**RE: JUSTICE COMPLEX TRUSSES**

**RE: Jonesboro Courts/Office/Police Center  
416 West Washington  
Jonesboro, AR 72401  
Recommended Truss Modification  
Our File 95-790**

STRUCTURAL INSPECTION REPORT

**TYPICAL TRUSS LOOKING SOUTH**  
**EXISTING WOOD TRUSS**

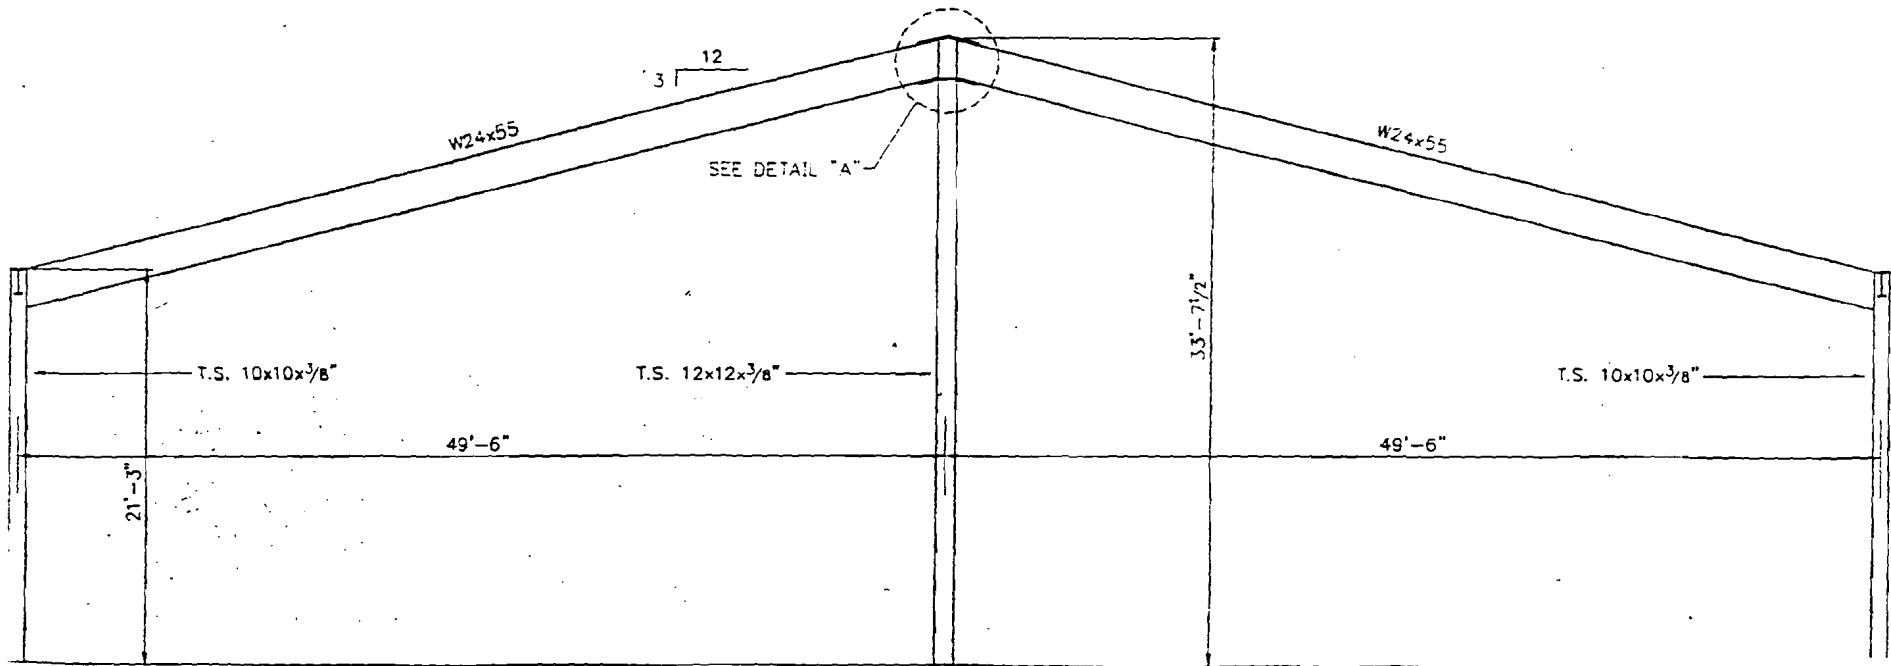
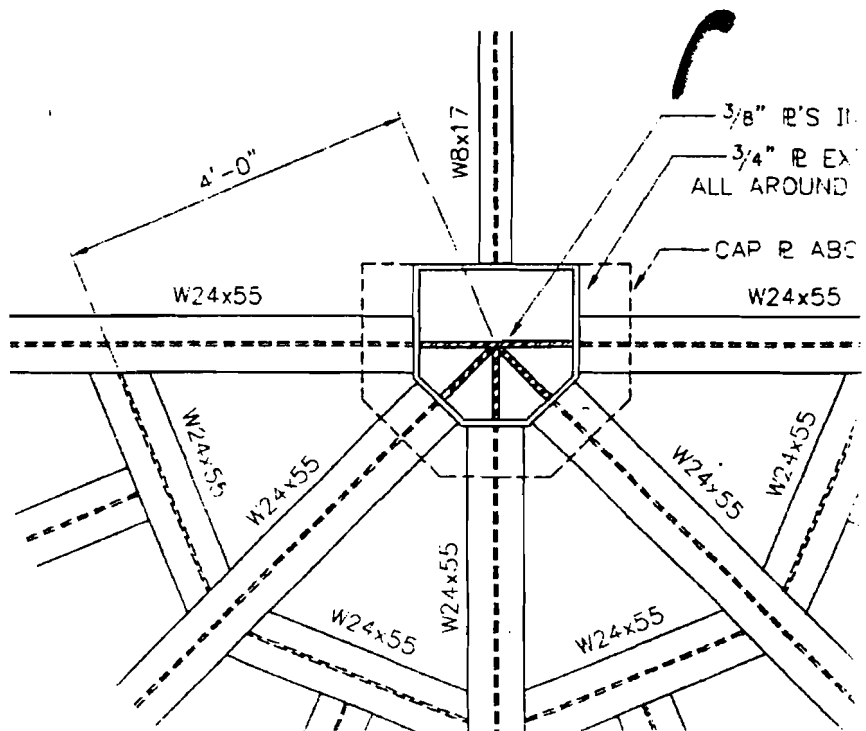
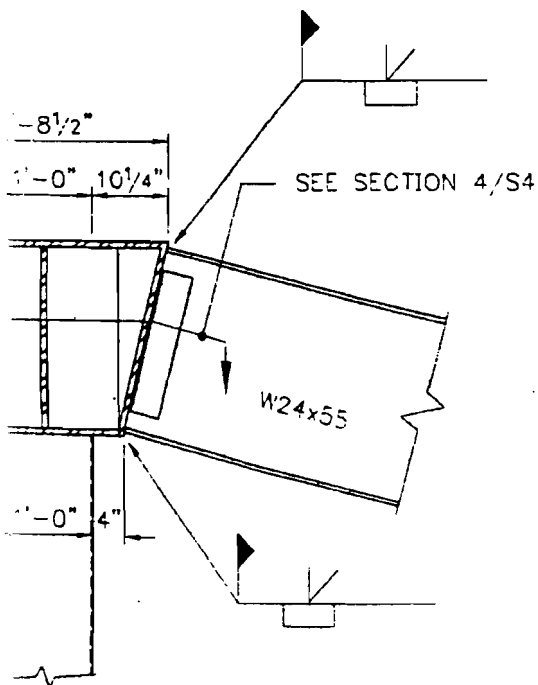
<b>TRUSS REPAIRS SCHEDULE</b>	
TRUSS NO	REPAIRS
TRUSS 1	REPLACE MEMBERS 16 & 18, PRESSURE GLUE MEMBER 17
TRUSS 2	PRESSURE GLUE MEMBERS 2, 7, 17 & 18 @ CRACKS
TRUSS 3	REPLACE OR GLUE MEMBER "C" & "J" GLUE CRACKS IN MEMBERS 5 & 20
TRUSS 4	REPLACE OR GLUE MEMBER "G" & "H" GLUE CRACKS IN MEMBERS 3, 17 & 18
TRUSS 5	REPLACE OR GLUE MEMBER "E" & "G" GLUE CRACKS IN MEMBERS 3, 17 & 18
TRUSS 6	REPLACE OR GLUE MEMBER "F" & "G" GLUE CRACKS IN MEMBERS 2, 19 & 20
TRUSS 7	REPLACE OR GLUE MEMBER "D" GLUE CRACKS IN MEMBERS 2, 5 & 14
NOTE	PARALLAM OR GLUE LAM LUMBER MAY BE USED AS REPLACEMENT MEMBERS IN PLACE OF SOLID MEMBERS IF DESIRED.

Figure 3 - Finite Element Model

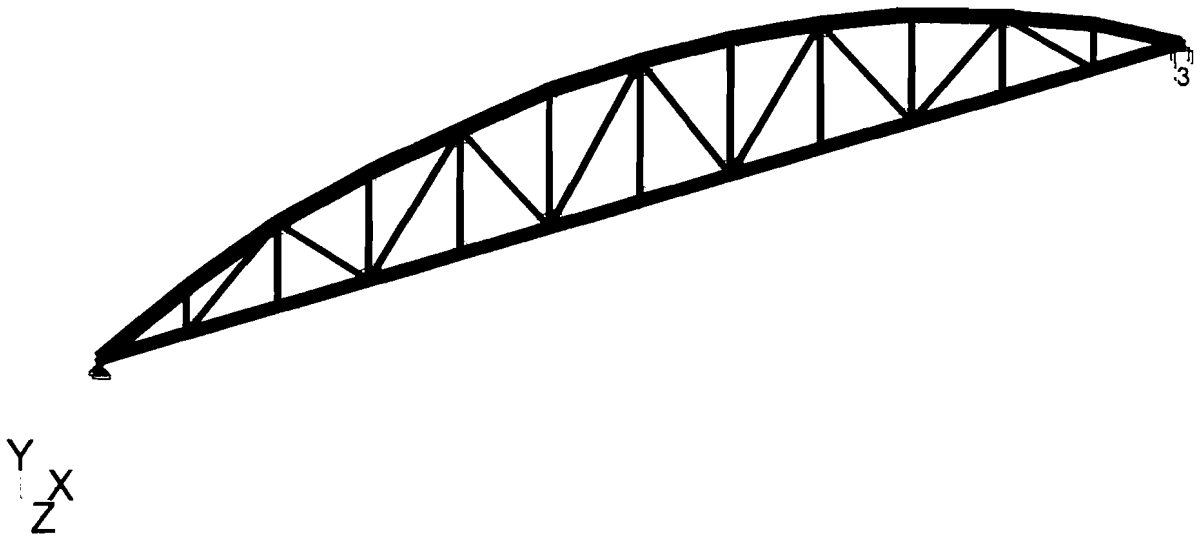
The trusses were reinforced with 1.5 inch steel tension rods that ran on each side of the truss. See Figure 3. The tension rods were attached to the truss at the ends of the truss. They were not attached to the truss at interior points. The center of gravity of the rods were 7.125 inches above the center of gravity of the bottom cord. This was modeled in the finite element model.

The truss was first analyzed for the existing dead loads with tension rods loaded with 200, 2,000, 5,000, and 10,000 pounds. The bending and axial stresses were calculated in the truss members. The stresses near the middle of the truss in the top and bottom cords are reported in Table 1. The stresses near the end of the truss where the rods are attached to the truss are also reported in the top and bottom cords. The allowable stresses for axial compression, tension and bending were obtained from a 1974 timber construction manual. This was done to account for recent reductions in allowable stresses for newer woods. The allowable stresses are presented in Table 1. The interaction equations were calculated for the truss members and presented in Table 2. The values should be less than or equal to one. The member stresses and interaction equations were also calculated for the dead load and a live load of 20 pounds per square foot on the roof. The results are presented in Tables 1 and 2.

The truss was modeled with one end pinned and the other end permitted to slide. This was done to account for the flexibility of the walls. The analysis of the dead load condition showed that the end of the truss slid 0.59" for a 200 tension pound load on the rods and 0.31" for the 10,000 pound load. The center line deflection was 1.46" and 1.14" respectively. When the live load was added to the truss, the end slid 1.16" and 0.88" for the 200 and 10,000 pound loads. The center line deflection was 2.89" and 2.54" respectively. The truss was 1172" long

The analysis revealed that the truss appears to be fully loaded when no live loads are applied to the truss. When the live load is added to the truss, the truss is over stressed and the factor of safety is being reduced. The vault action of the wood decking was not accounted for along with the diaphragm action or stiffness of the plywood attached to the bottom cord. These actions would help to reduce the chances of the collapse of the roof. The vault action would be limited by the lack of blocking between the 2x12's at load points and the methods of securing the 2x12's to the truss. If there is a large snow or ice load on the roof, care should be taken. The roof had been tested during the recent ice storms.

By placing columns from the floor to the bottom and top cord of the truss along the hall on the other side of the back wall of the court room the stresses in the roof trusses would be reduced. The interaction equations would be close to one in the truss with full live load. This should be investigated by further study and design.
